DESIGN ALTERNATIVES:

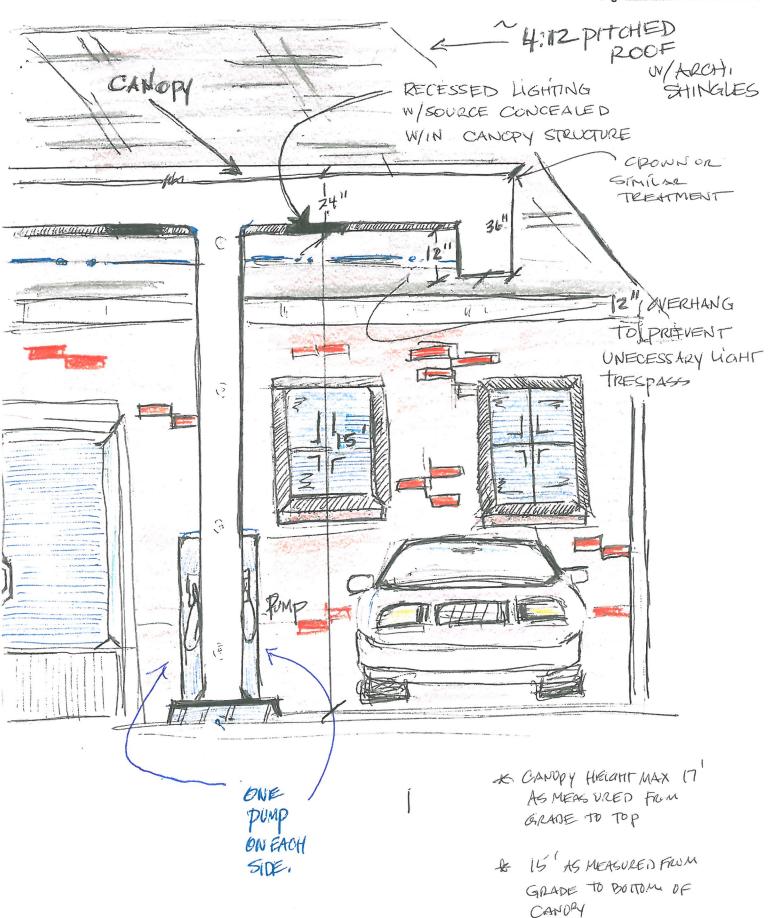
- c. Gas Canopy To facilitate compatibility and a more rural scale, the gas canopy shall be no greater in height than 17 feet, as measured from grade to the top of the canopy. The height of the canopy, as measured from the underside of the canopy to grade, should be no taller than 14 feet. The canopy should incorporate into the design, 12 inch overhangs with recessed lights that reduce the amount of light trespass. The number of lights and wattage of bulbs utilized under the canopy should be minimized to reduce light trespass while maintaining a safely lit environment for patrons and employees. No canopy lighting, other than recessed lighting underneath the canopy should be utilized. Lighting underneath the canopy shall be limited to those areas directly over the fuel pumps. The gas canopy should not incorporate any advertisement, logos, striping or insignia. The finish of the canopy should not be a glossy or highly reflective finish. Architectural features incorporated as part of the building design should be utilized and carried into the design of the gas canopy.

- e. **Building Architecture** The building shall include materials such as brick or stucco (or combination of materials), which would be consistent with the exterior materials used with nearby structures. The building shall utilize earth-tone colors and avoid use of any highly-reflective materials. The convenience store building shall incorporate a pitched roof (4:12 roof pitch or better) design. Recessed windows shall

be included on the front and sides of the building. Faux windows are acceptable on the sides of the building. The use of windows on the storefronts shall be divided into smaller individual windows or groupings of windows. Large plate glass windows frequently utilized in more urban settings shall not be used.
